No. 0940, Rev. I
ATA Code 27-50

SUBJECT: FLIGHT CONTROLS - REPLACEMENT OF THE FLAP CONTROL WELD ASSEMBLY

SYNOPSIS OF CHANGE: Added improved bushings on MB-1 through MB-193, MB-195 through MB-200, M-1 through M-1100 and MA-1 through MA-200. Those airplanes previously modified by the original issue of these Service Instructions are not affected by this revision.

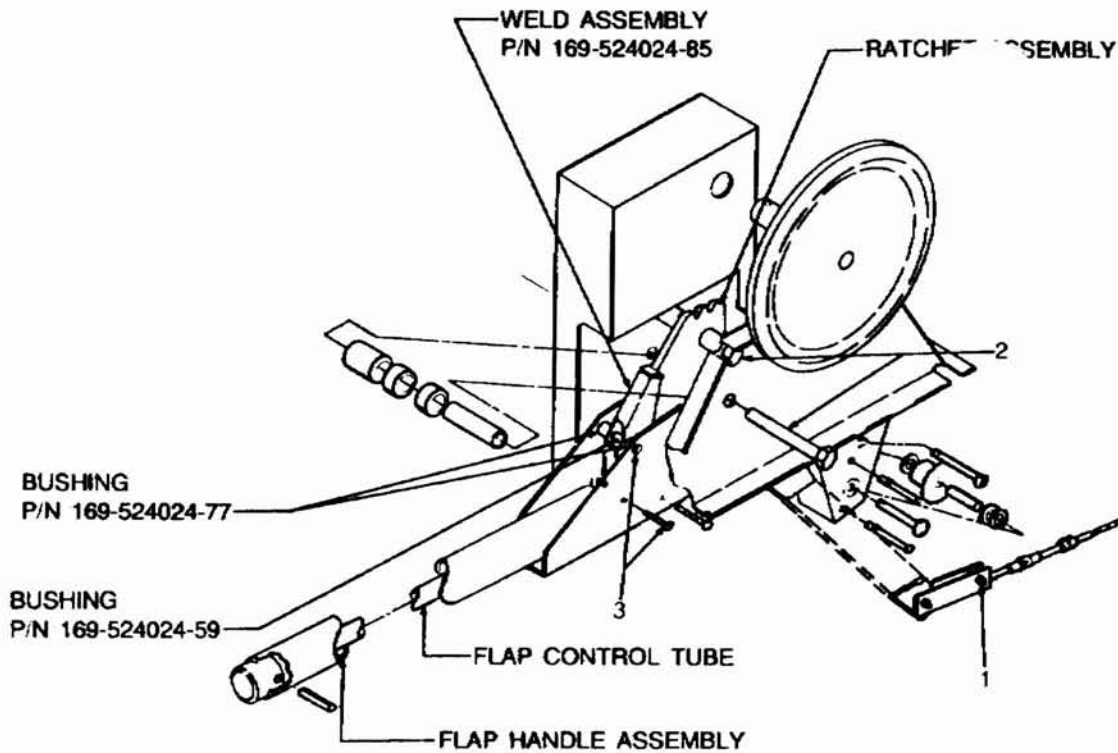
1. Remove the pilot chair and the copilot chair.
2. Remove the floorboard and access plate immediately aft of the trim console.
3. To facilitate reassembly and rerigging, temporarily secure the flap control cable to the airplane structure using blocks and clamp. Disconnect the flap cable eye from the flap control link by removing the one attaching bolt. Refer to index number (1) on the illustration. Retain the attaching hardware.

4. Remove the two bolts that secure the flap handle assembly, flap control weld assembly, and ratchet assembly to the trim console. Reference index (2) on the illustration. Retain all attaching hardware.

5. Remove the flap handle assembly, flap control weld assembly, and ratchet assembly from the trim console.
6. Remove the one bolt and one clevis pin that secure the flap control weld assembly to the flap handle assembly. Remove the flap control weld assembly. Reference index (3) on the illustration. Retain the attaching hardware.

7. On airplanes listed under Part I of the EFFECTIVITY section, replace the two existing P/N 169-524024-61 side bushings with the new P/N 169-524024-77 side bushings and install the new P/N 169-524024-85 weld assembly, using the existing bolt, nut, washer and P/N 169-524024-59 through bushing. On airplanes listed under Part II of the EFFECTIVITY section, use the existing bolt, nut, washer and bushings.
